Notice of Allowability

09/884,091

AKIYAMA ET AL.

FIG.1

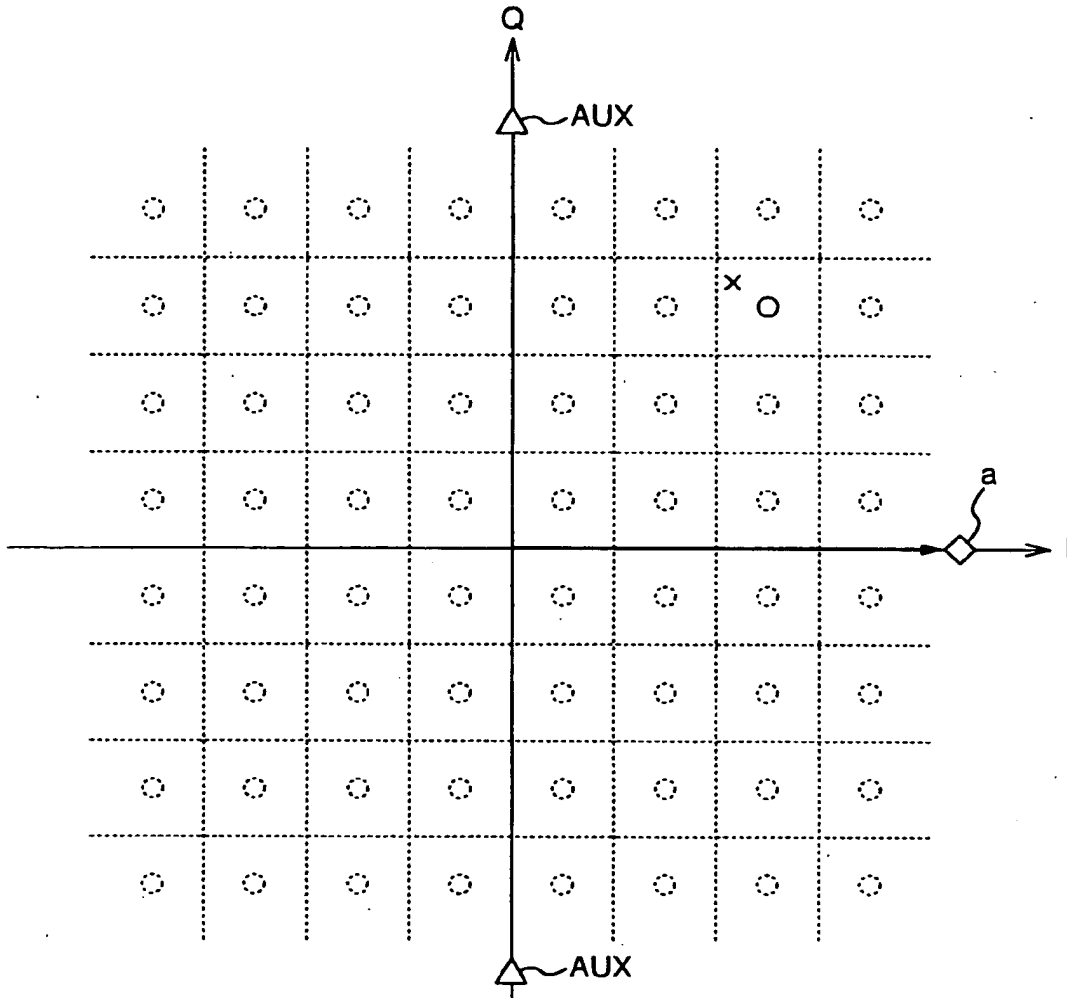
2. The drawings were received on April 8, 2005. Figures 3-6 of the drawings are accepted. However, a new replacement sheet for Figure 1 is required. The new replacement sheet should incorporate the correct spelling of "AXIS" instead of showing the "AUXIS" as crossed-out.

Not Accepted.
